Re: Comments of Iberdrola Renewables, Inc. regarding the Tule Wind Project Draft DEIR/DEIS- Modified Project Layout

Tule Wind, LLC, a wholly owned subsidiary of Iberdrola Renewables, Inc. (IRI), submits this letter to summarize proposed minor modifications to the Tule Wind Project since the project was submitted to you with IRI's Applicant Environmental Document (AED) in September of 2010. Submitted herewith is a modified project layout in GIS format and other information, such as recently completed surveys and technical studies that have been revised based upon the Tule Wind Modified Project Layout. Enclosed with this letter are specific suggested edits to the Draft Environmental Impact Report/Environmental Impact Statement (EIR/EIS) in "track changes" format to help facilitate incorporation of the minor changes resulting from the Modified Project Layout into the Final EIR/EIS as the applicant's proposed project. IRI submits this information to the Lead Agencies to supplement IRI's comments on the Draft EIR/EIS for the Tule Wind Project submitted under separate cover.

Figure A-3: Preliminary Underground Alignment Drawing 1 of 10

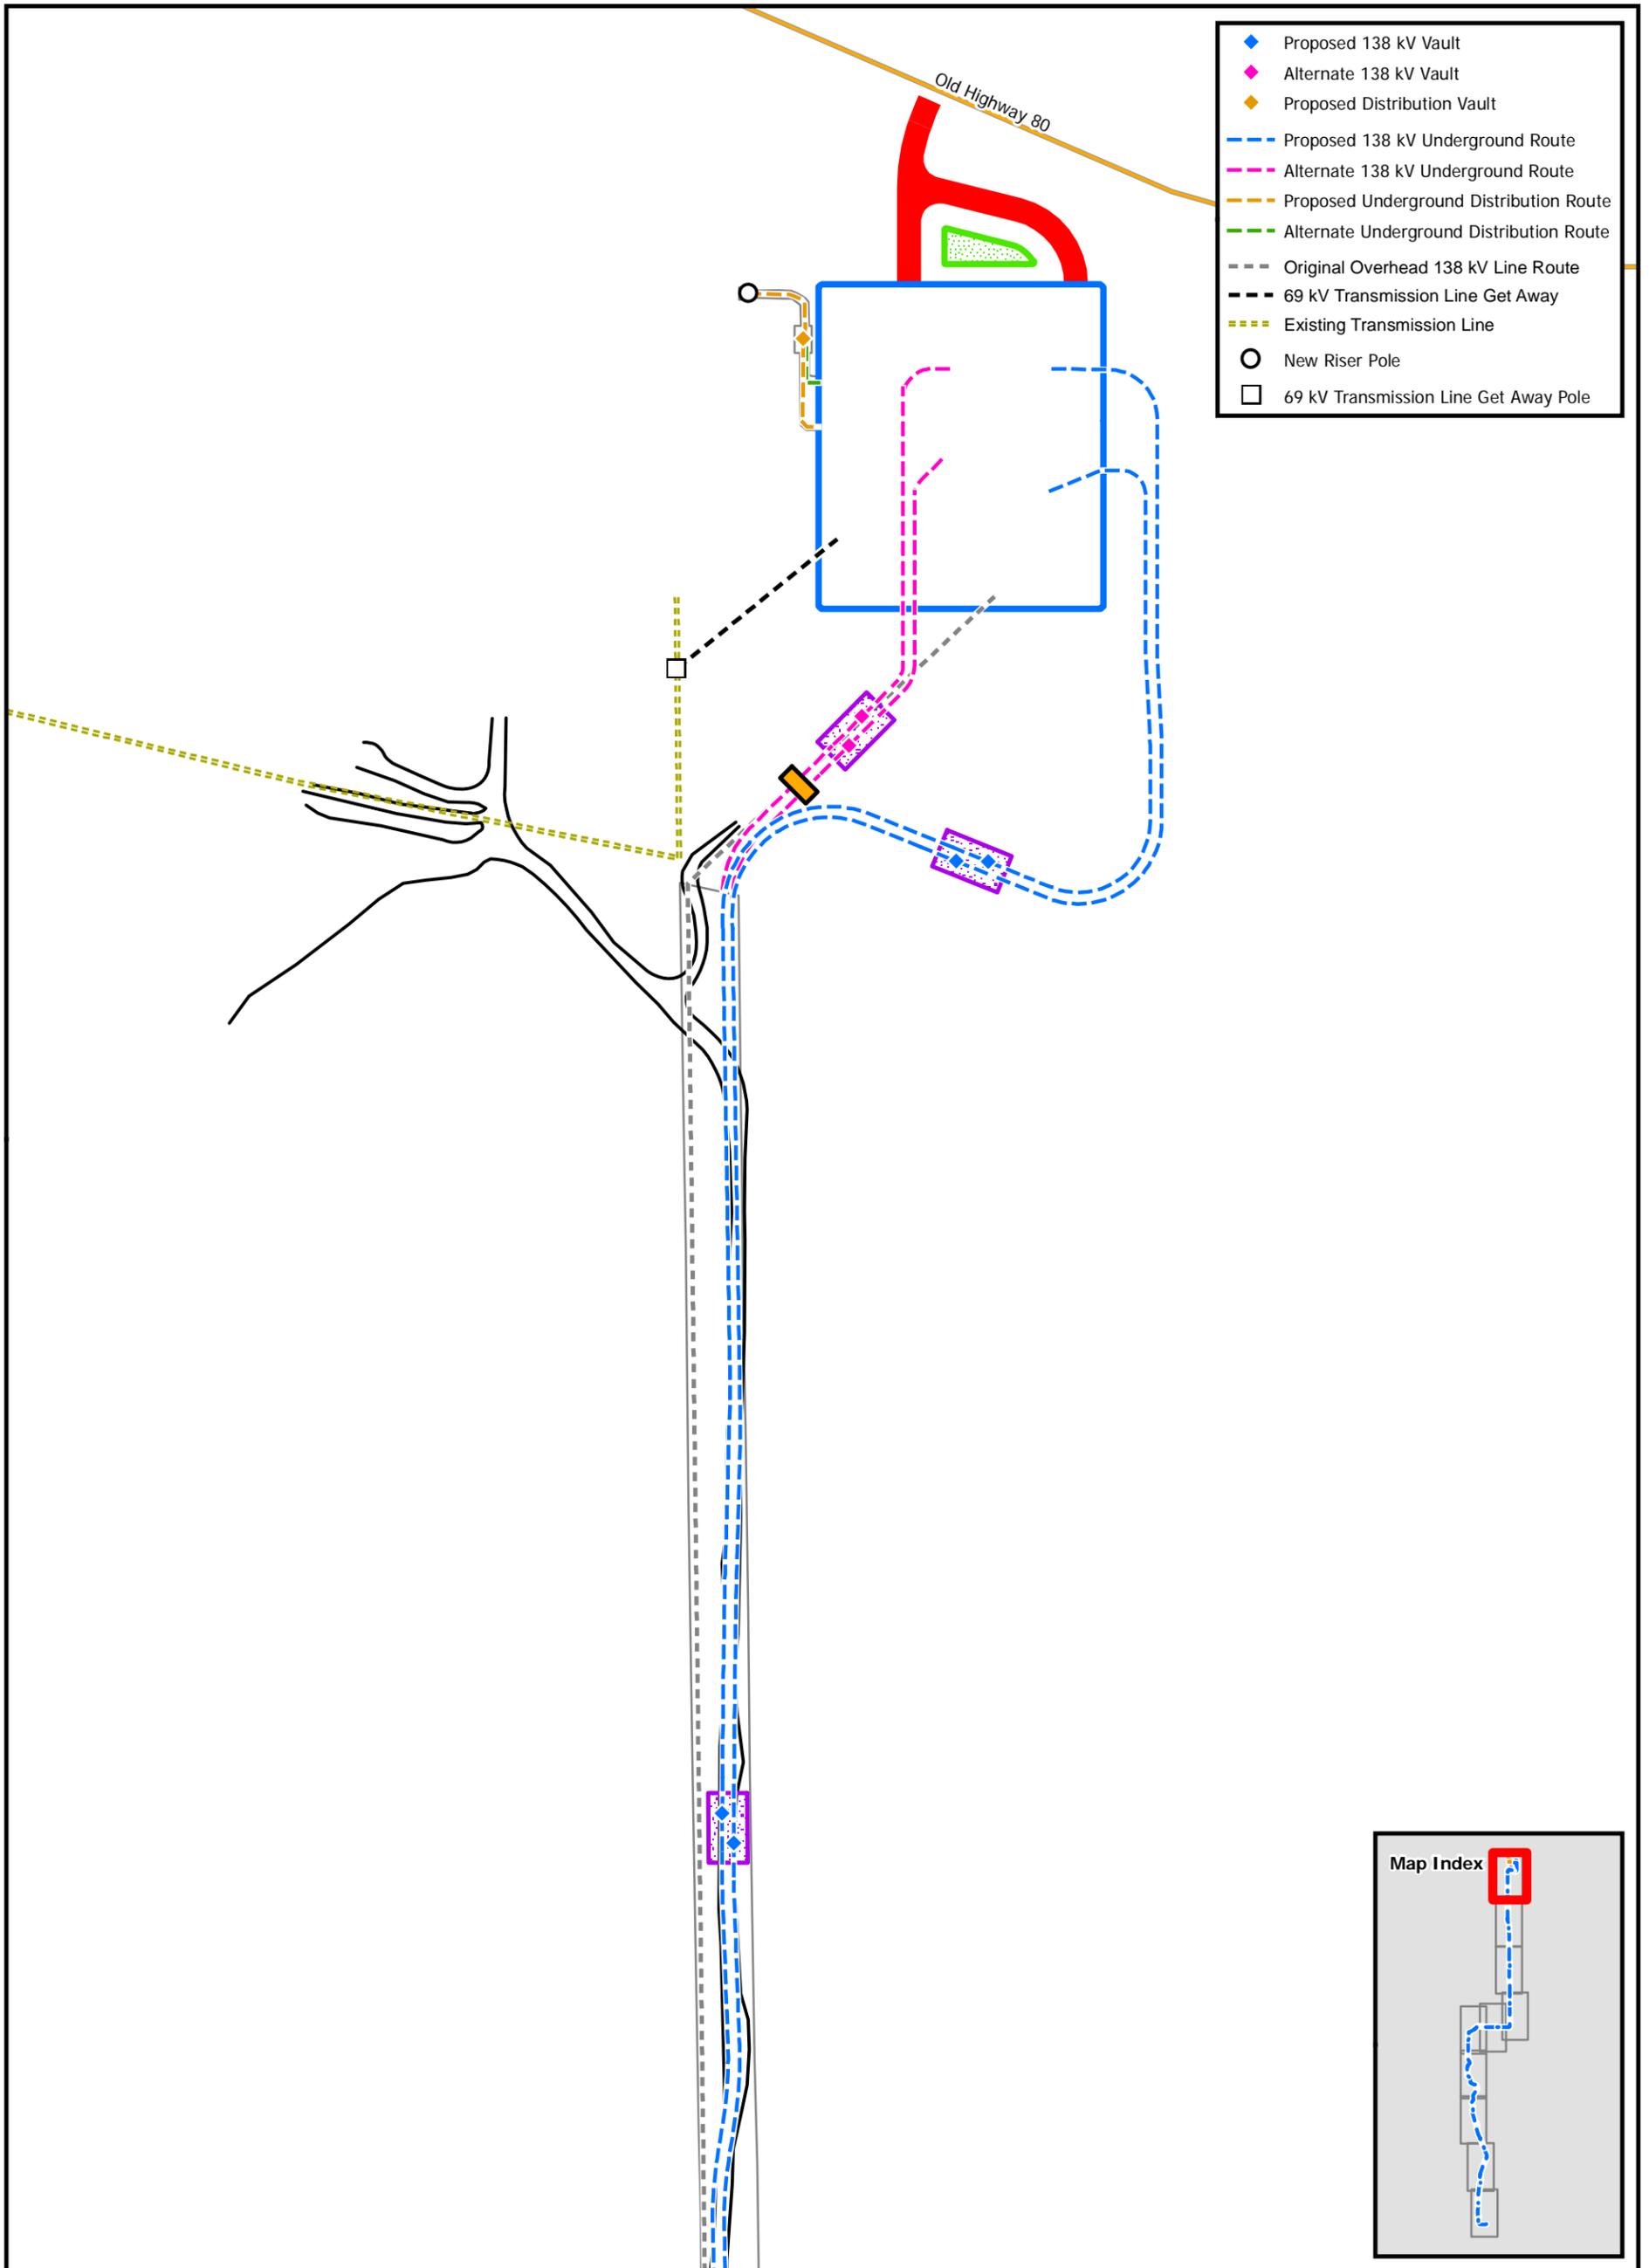
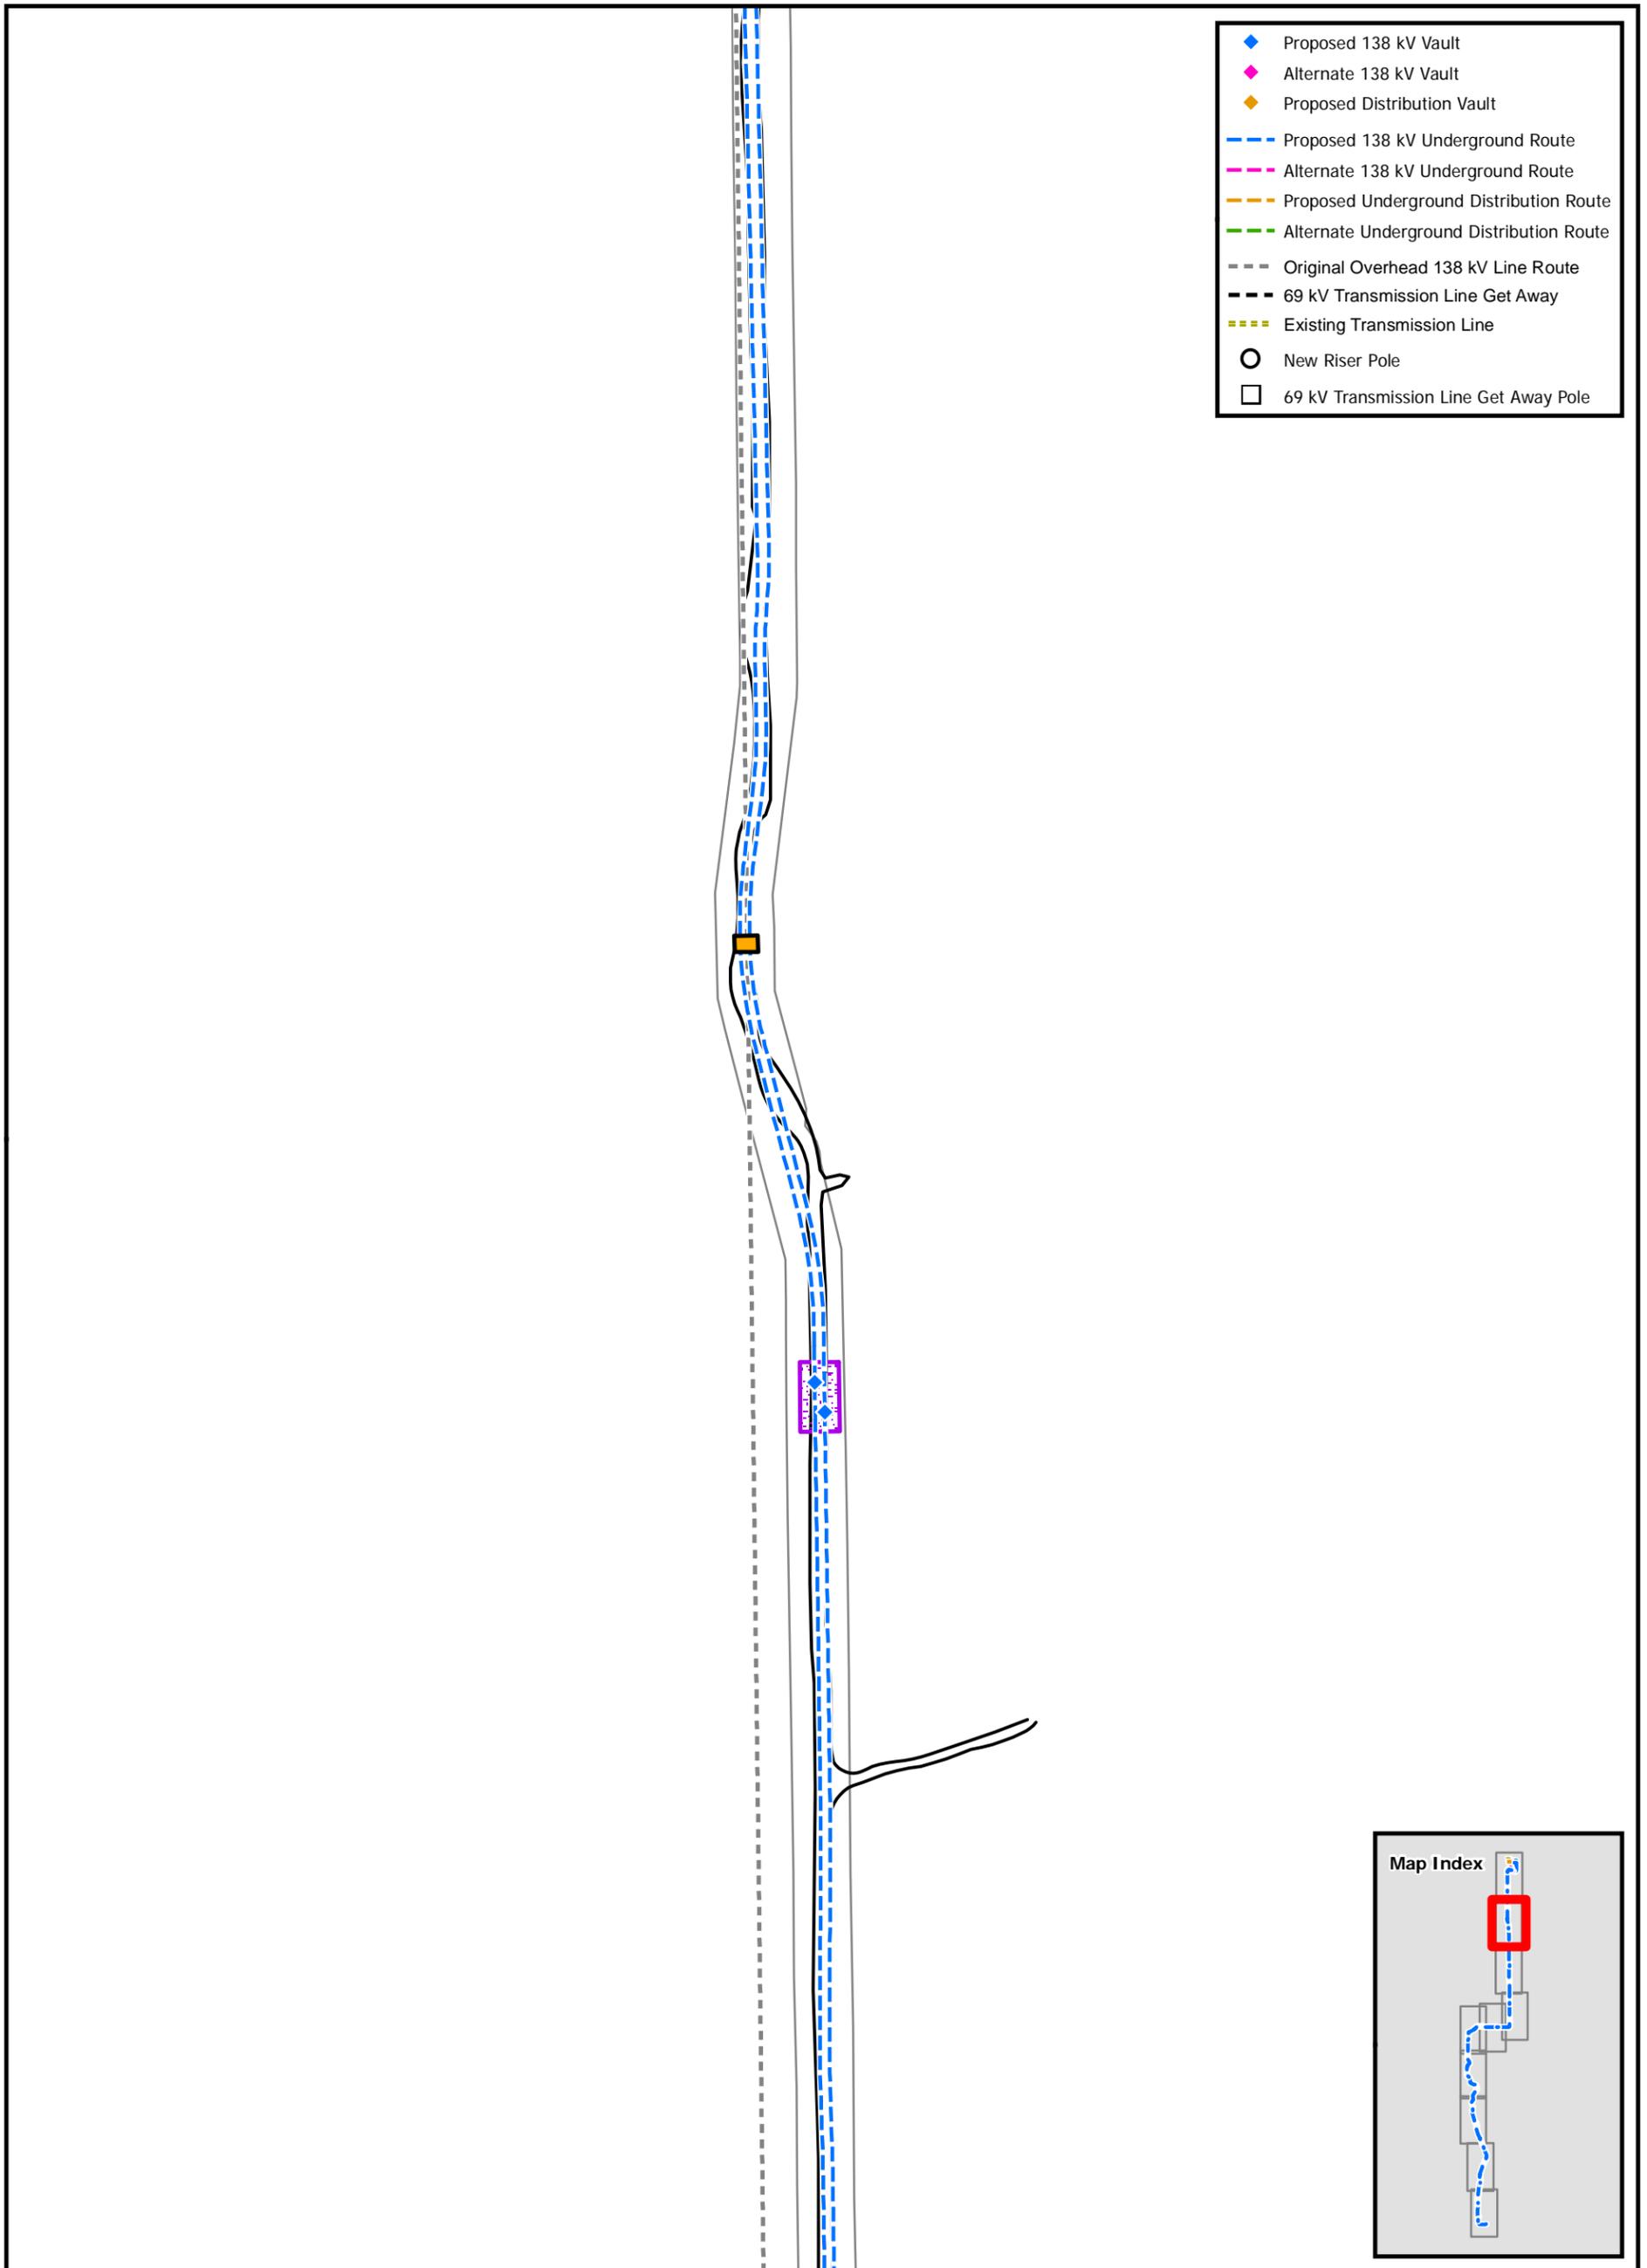
In order to assess the potential impacts to biological, cultural, and hydrological resources from the partial underground portion of the Project, field surveys of the area were conducted in February 2011. From the results of these surveys, SDG&E prepared a feasible preliminary design of the underground section of the Partial Underground Alternative, which is depicted in the attached Figure A-3: Preliminary Underground Alignment Drawing. Based on this preliminary design, the overhead portion of the 138 kV transmission line would transition to an underground configuration at two new riser poles located within the same permanent pole work area previously designed for steel pole 38. From these two new riser poles, two parallel duct banks separated by up to 20 feet would be installed typically within or directly adjacent to existing roads in the area. The duct banks would measure approximately 4.1 miles long and each would pass through approximately 11 vaults before terminating at the Boulevard Substation. The duct banks would be installed using the direct trenching method of construction in all but two locations. An approximately 690-foot-long segment would be installed using the horizontal directional drilling method to cross under a large jurisdictional feature and an approximately 280-foot-long segment would be installed using the jack-and-bore method to cross under an existing San Diego & Arizona Eastern railroad.

The impacts of the underground alignment were then determined based on a worst-case scenario (since there are two alternative routes into the substation as depicted in Figure A-3: Preliminary Underground Alignment Drawing that are substantially similar). As demonstrated in Table A-7: Preliminary Partial Underground Impacts, these impacts would not be substantial and would not therefore be significant.
